**JOINT REGIONAL PLANNING PANEL  
(Region)**

<b>JRPP No</b>	<b>2013SYE031</b>
<b>DA Number</b>	<b>DA2013/0412</b>
<b>Local Government Area</b>	<b>Sydney East Region</b>
<b>Proposed Development</b>	<b>Stage One Redevelopment of the Harbord Diggers Club Site for seniors housing, new club facility, child care centre, gymnasium, community centre and respite care centre.</b>
<b>Street Address</b>	<b>80 Evans Street and 4 A Lumsdaine Drive, Freshwater</b>
<b>Applicant/Owner</b>	<b>Urbis Pty Ltd</b>
<b>Report by</b>	<b>Malcolm Ryan, Deputy General Manager, Environment</b>

**Supplementary Assessment Report**

(Figure 1 – identifies the non-compliance with building height - Source: SEPP 1 objection, prepared by Urbis)

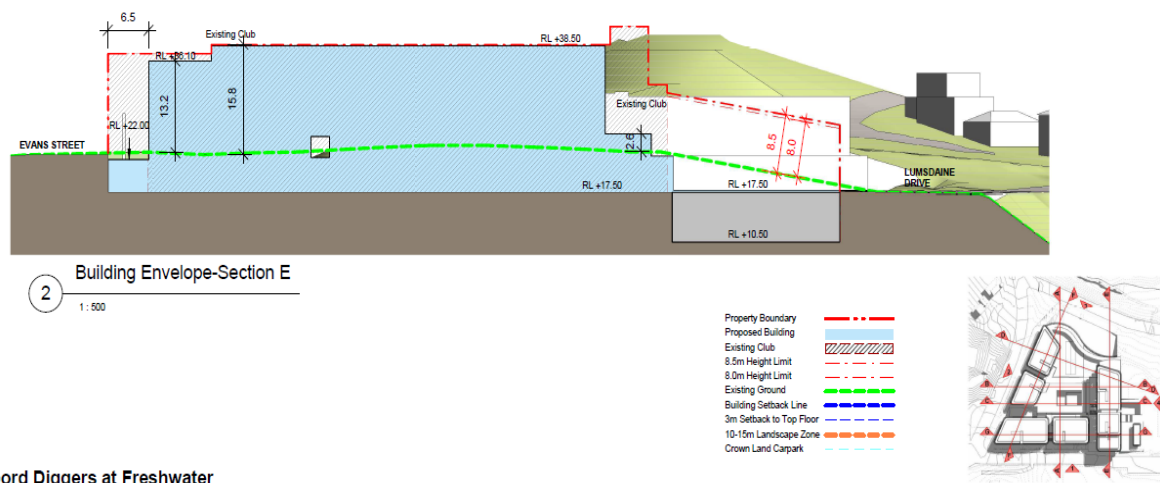
Figure 1 below shows the extent of non-compliance with regards to Building D.

**Comment:** The non-compliance with the height standard will not result in inconsistencies with this objective as Building D adjoins a public reserve to the east. However, it is noted that a compliant building would achieve greater consistency with this objective. The visual impact of the development is unacceptable in its current form. In particular, Building D reaches a maximum height of 15.8m and is the most dominate built form on the site and will be readily viewable from many vantage points.

**Comment:** The non-compliance with the height standard will result in inconsistencies with this objective as it will result in adverse visual impact when viewed from the adjoining public open space areas.

The site shares a boundary (eastern) with McKillop Park, which is dominated by low scrub, grassed areas with public walkways. Building D is located partly with a nil setback to this public open space and reaches a maximum height of 15.8m on this elevation. It is therefore

considered that the development maintains a visual massing and building bulk that will result in an unreasonable impact on the adjoining public open space area.
